GULMOHAR RESIDENCY

Details of Additions & Alterations

Flat No	C-607	Block no.	C
Flat Area	1660 sqft	Type	Deluxe / Luxury
Buyer Name	Hani Krishna / Shilpa		
Phone No.	7875602288	Email	hani6838@gmail.com.

Description 6-BLOCK-Flat no-7-East facing- Working plan	Direction 	Owners & Developers : Modi Reality Mallapur LLP Project Name & Phase : Gulmohar Residency	Date : 21.05.2023 Prepared By : Jayapratha Approved By : Soham Modi Scale : N.T.S. Promoted by : Modi Properties Pvt Ltd Phone : +91-40-66335551
---	--	--	---

Changes in flooring:

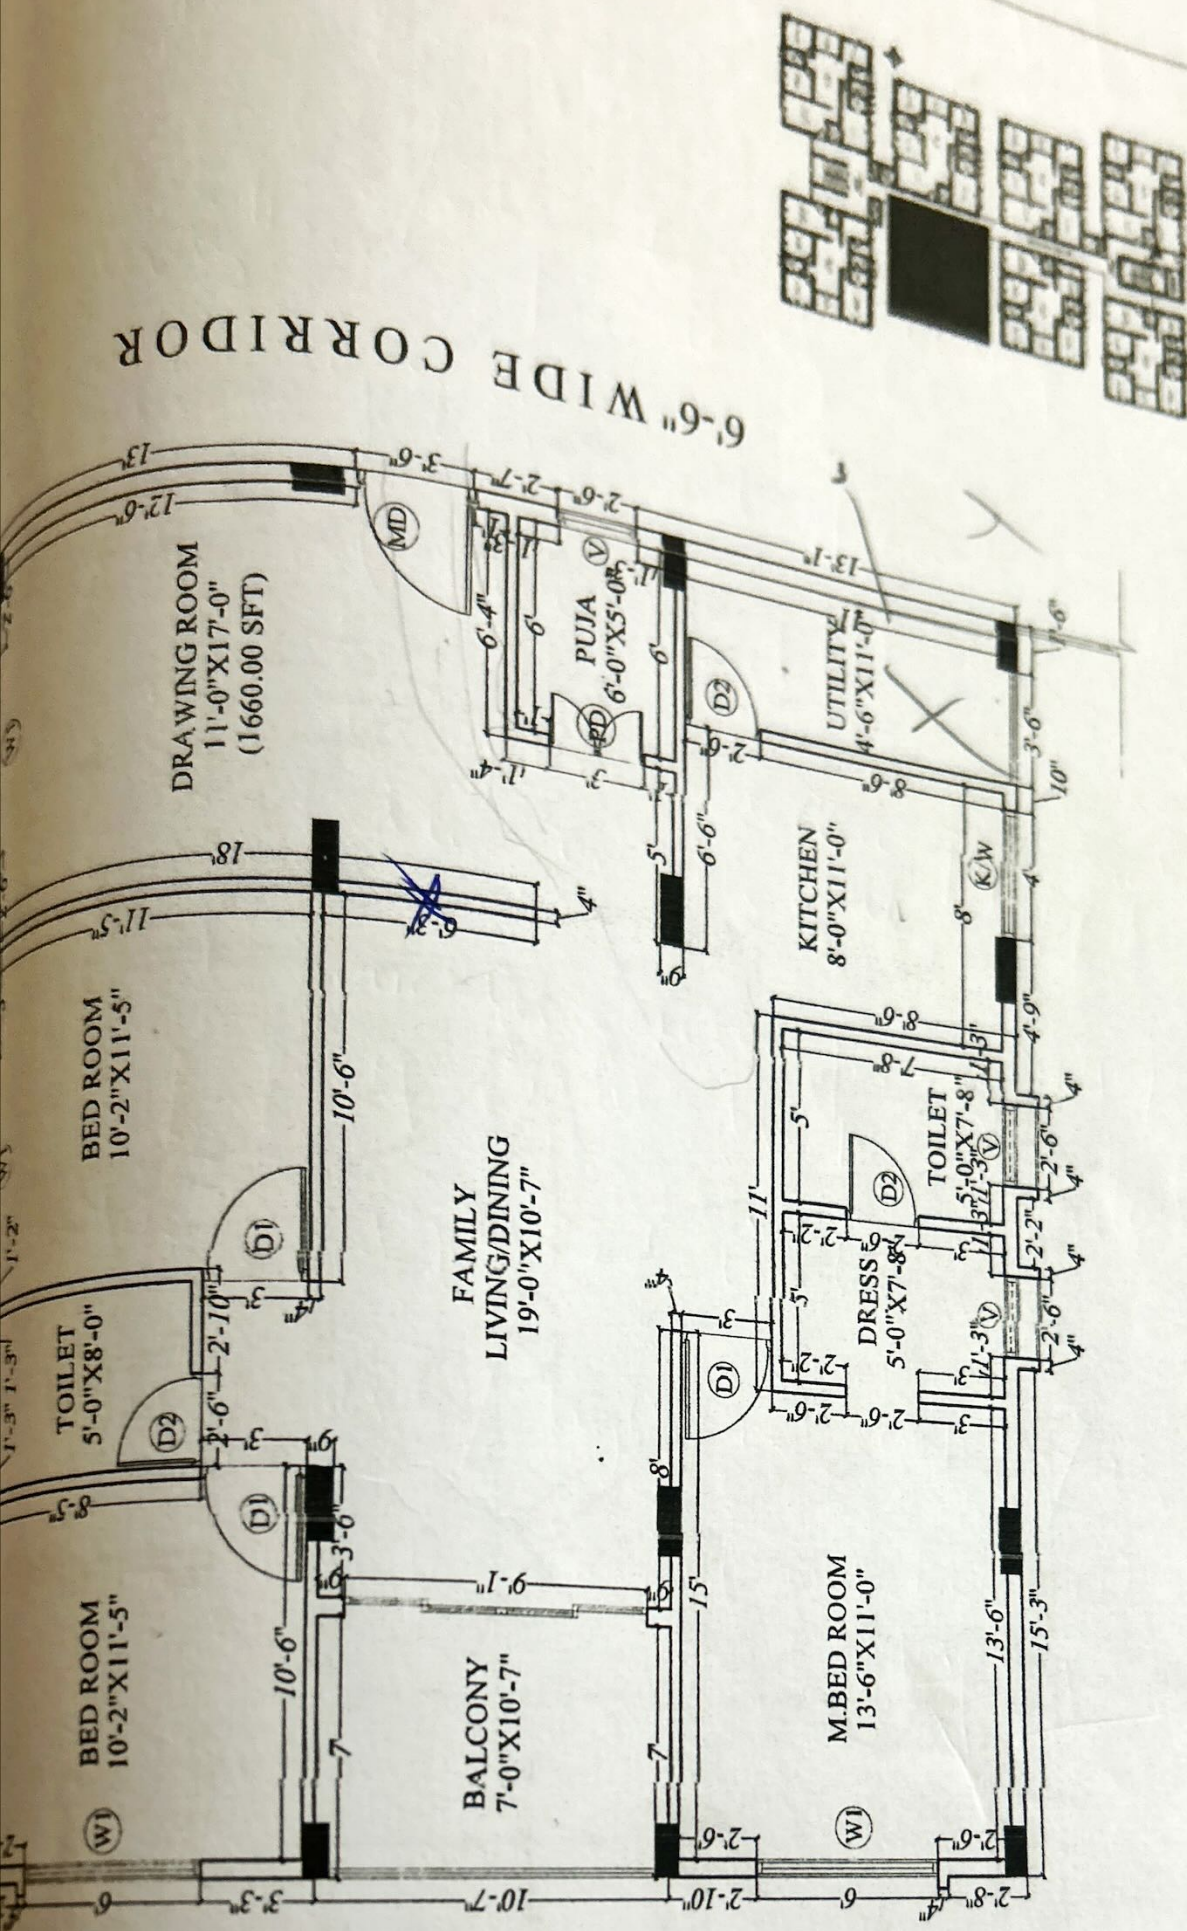
- ① Wash Basin point - b/w Kitchen & Master bedroom - Completed Srikalya
- ② Gato loppam / color for full ceiling in living room & dining room - Working Rao
- ③ Bathrooms finishings not done - Working Rao
- ④ grills not done Completed - praveen.
- ⑤ In main living room electric pipe must be hidden in the wall - Completed Raju.

- ⑥ In main living room finishing not done properly (wall edge broken) - Completed praveen.
- ⑦ Kitchen platform will be inserted (white color) not covered - after cool work
- ⑧ lights points / lights not installed (17)
- ⑨ Kitchen wash basin we will insert (Bigger one) by

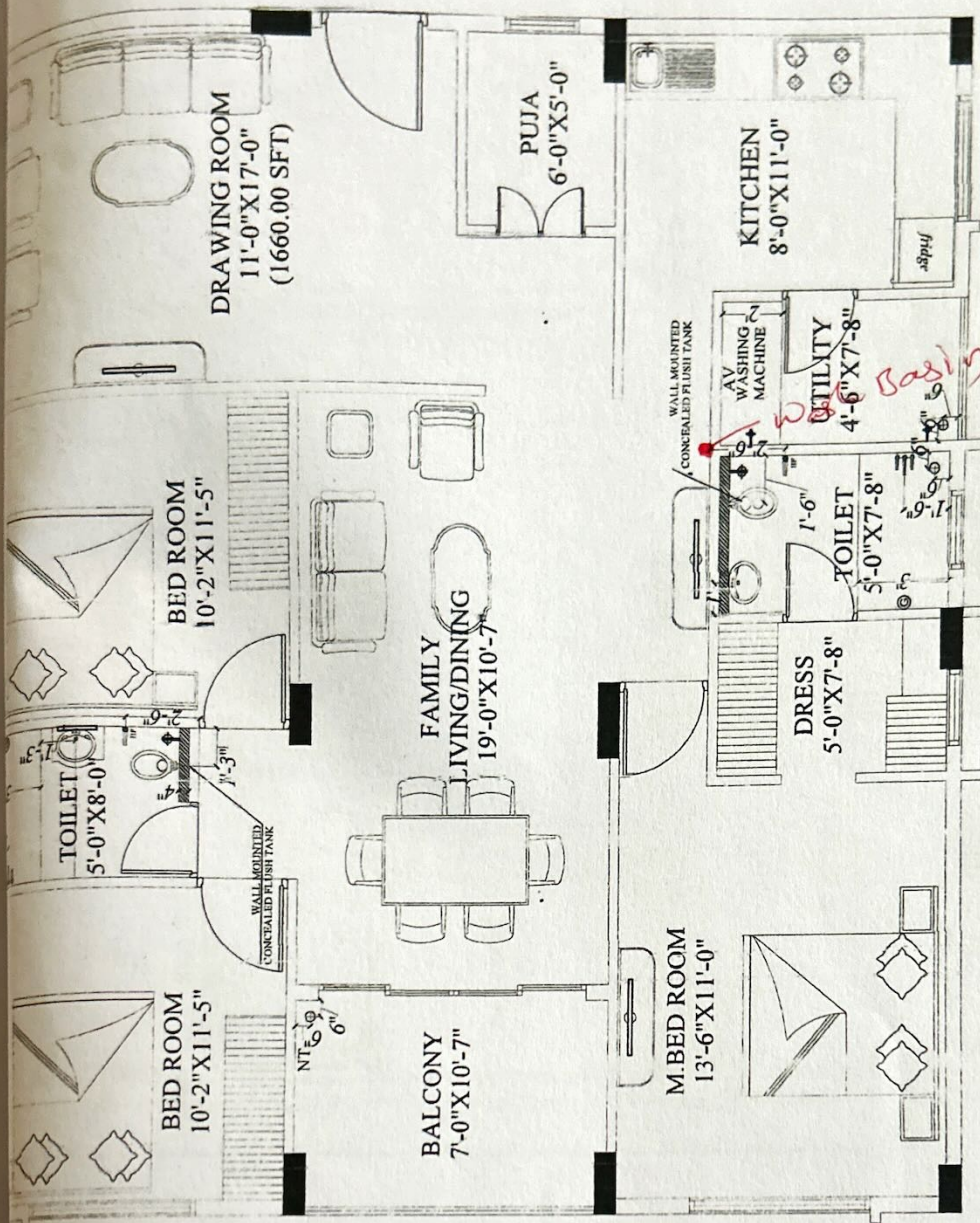
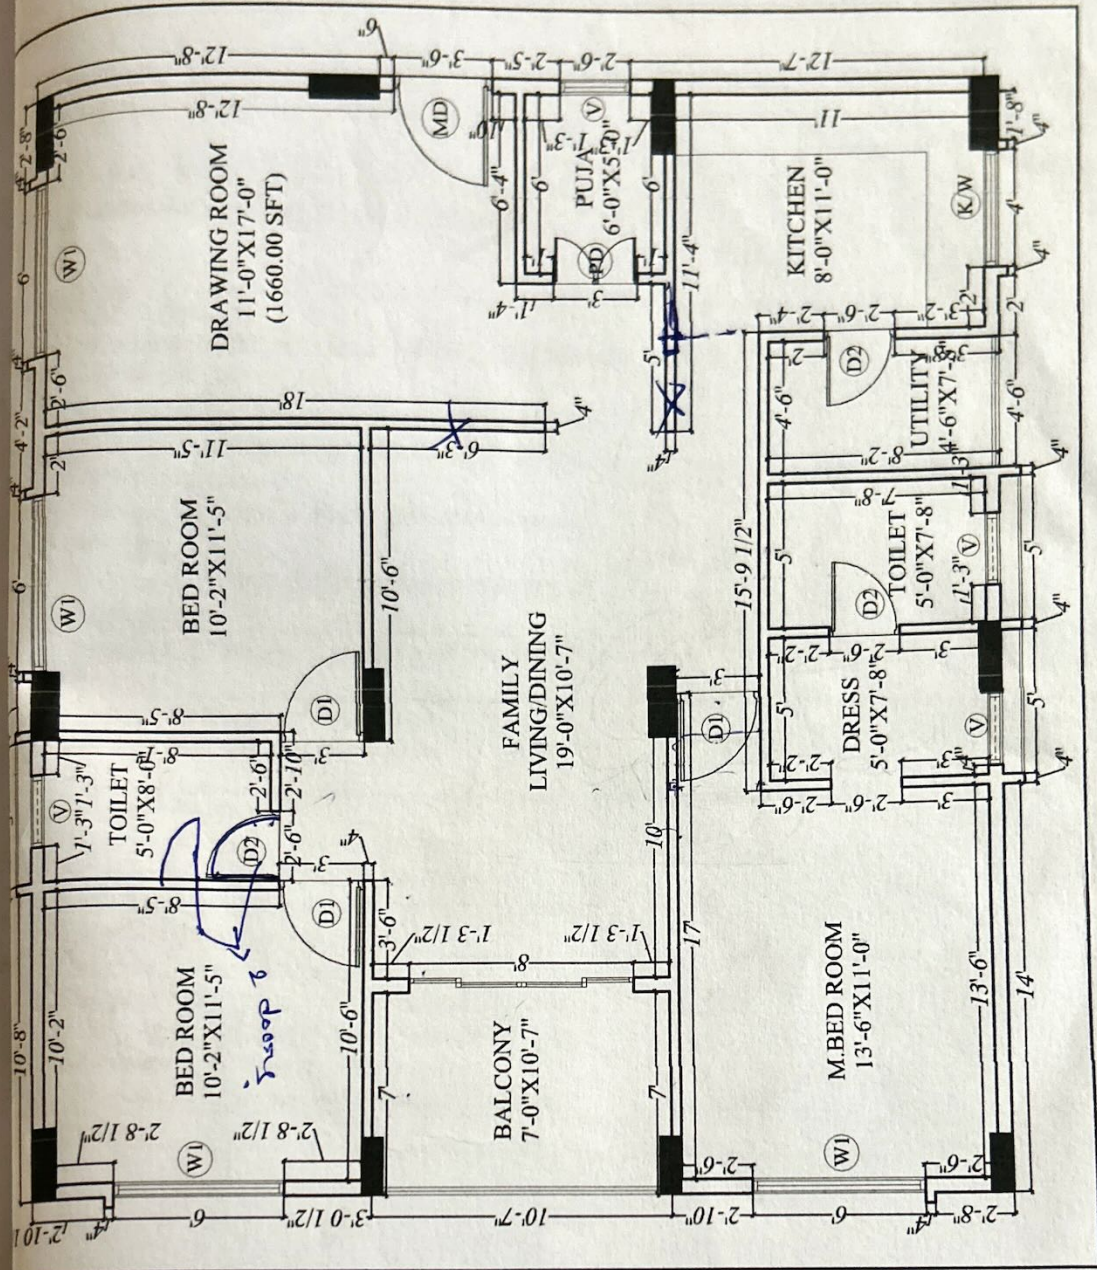
- ① Wash Basin point b/w Kitchen & Master bedroom
- ② Color/lapam did not.

- ① C.T. require extra door, ✓
- ② Partition wall in hall not required, ✓
- ③ Kitchen wall to be done as mentioned in plan, ✓

④ Wash Basin point in b/w kitchen and M. Bed room

⑤ chimney hole must be done.
